**42-44 BOOREA  
STREET,  
LIDCOMBE  
SSD-36464788**

Submissions Report

Figure 1 – Ground Floor Plan

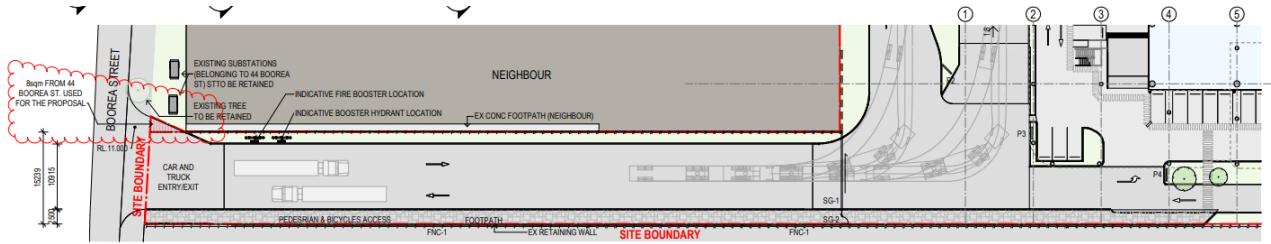
Clause 37 of *Environmental Planning and Assessment Regulations 2021* requires an amended application to provide details of the change, including the name, number and date of any plans that have changed, to enable the consent authority to compare the development with the development originally proposed. Three plans have been updated to incorporate part of the lot including:

An extract of the Ground Floor Plan, Figure 1 clearly shows the lot boundaries overlaid with site boundary extent required. The additional 8m<sup>2</sup> area is clearly identified on the plan with a 'bubble' around the amended

portion of the site area extending onto the adjoining lot. The total developable area has increased by 8m<sup>2</sup> to 41,069m<sup>2</sup>. As shown in Figure 2 the additional area to be included in the site area is a grass verge.

- Site Analysis Plan and Summary DA050 Revision H dated 2.12.2022
- Ground Floor Plan DA100 Revision N, dated 2.12.2022
- Services/Constrains Plan DA 106 H, dated 2.12.2022
